Planning Sub Committee – 10 January 2022

ADDENDUM REPORT

UPDATE FOR CONSIDERATION AT PLANNING SUB-COMMITTEE Item No. 8

Reference No: HGY/2021/2031	Ward: Woodside
Address: Wood Green Social Club, 3 & 4 Stuart Crescent, London, N22 5NJ	
Proposal: Partial demolition of rear extensions and construction of 5 x part two, part three storey mews dwellings. Demolition of three storey front projection, demolition and reconstruction of existing 2 nd floor of 'Social Club' building and change of use of first floor from Community use to C3 (Residential) with balcony areas and internal re-configuration of existing 5 no. residential units within 3 & 4 Stuart Crescent and creation of an additional 9 no. residential units with associated landscaping works and parking.

Photos of the site May 2012

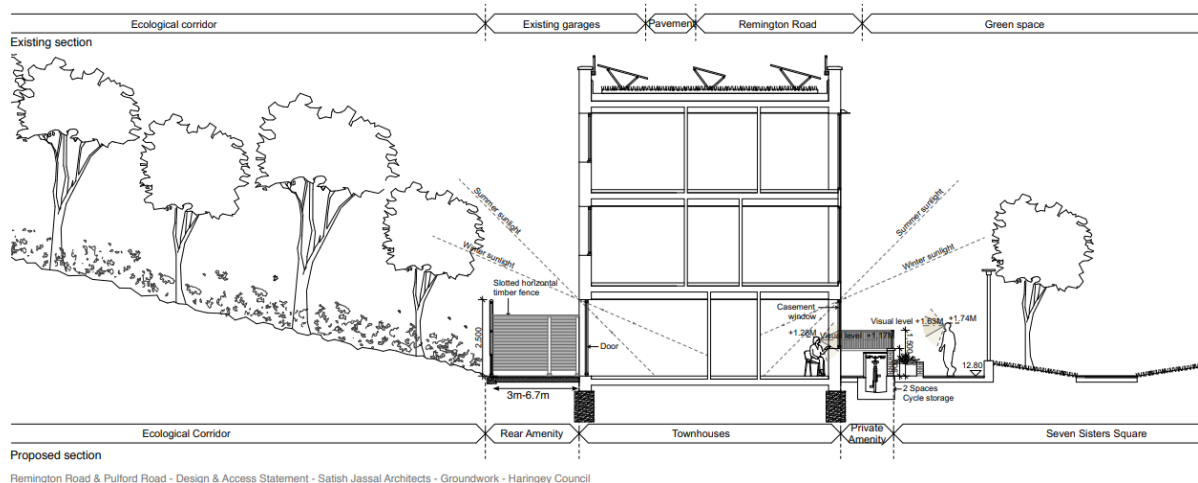
The applicant might claim that these aren't designated spaces but they are clearly amenity recreational areas intended for the existing council estate.

Also, I have been unable to confirm if this statement from a resident is correct but feedback received by the council from a resident claims that this site was created by a train crash that killed residents in the homes that existed on the site in the 50s, and that the council promised residents they wouldn't build on the site due to those deaths. If this is the case anywhere but a council estate this would be considered a memorial garden.

Representation	Applicant response
<p>If you are talking about the land by the bridge. In the fifties a train came off the tracks and rolled down the bank into the street. The Council gave the families assurance that the ground would not be built on. So many people lost loved ones and it was the people in the street houses that spent five days to dig them out. So are you saying the Council are going back on their word.</p> <p>Don't let the promise the Council made to the dead be broken.</p>	<p>The proposed development has been designed having regard to the constraints and opportunities presented by the site and local housing need.</p> <p>It is not uncommon for new residential development to be located close to railway lines; however, the proximity of the railway in this instance has been considered in consultation with the rail operators and the site is not considered inappropriate for residential purposes. Should the planning application be approved, further engagement with the rail operators will take place to ensure the development is compliant with the appropriate regulations.</p>

Through the S105 consultation process, 671 households were consulted who live close to the proposed site to inquire if they use the open space.

In summary:

- Only 17 use the open space.
- Only four use the open space on a daily basis.

At the statutory consultation, there were no objections from households who live in the immediate area.

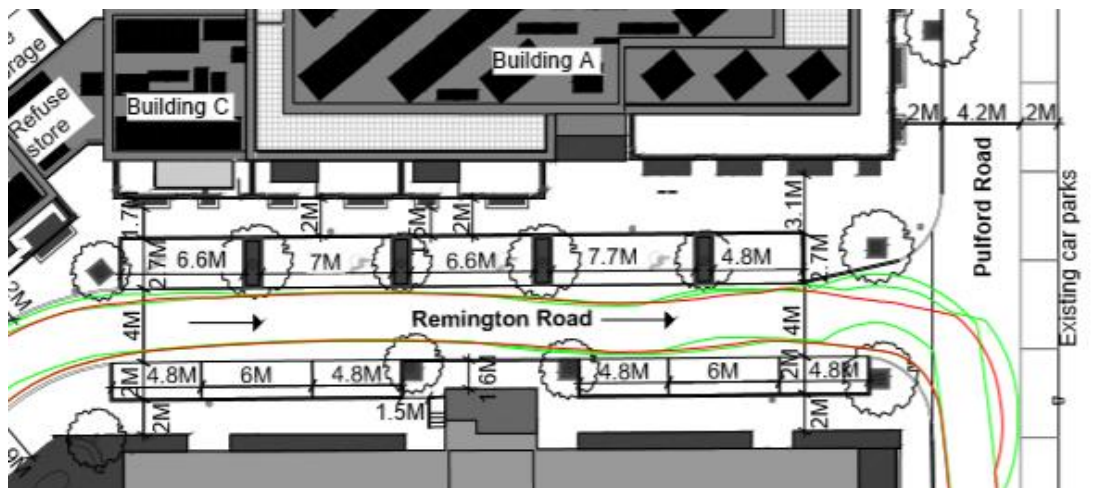
One concern with the daylight and sunlight report produced is that as standard they don't include trees in its analysis of light levels, while this raises concerns for the disabled residents who will already face low or no level of sunlight outlines above as there will be trees introduced outside of their home at the front and rear (x amount of trees added to rear communal garden) and this dense tree growth should have been analysed in the daylight and sunlight report)

However this decision was particularly inappropriate at the rear of the townhouses

These face out towards the slope of the railway line and face a thick forest of trees which rises to 3 stories above them. As show on the diagram above, only during the height of summer would light reach the ground floor windows of the homes, and the gardens would never receive direct sunlight. In the Townhouse type TH.C this ground floor room would be the dining/living room and would receive no through light from the front of the house due to internal walls, leaving the main living space of the homes receiving sunlight only on rare occasions in summer.

The daylight and sunlight for internal rooms assessment has been carried out based on the established BRE criteria.
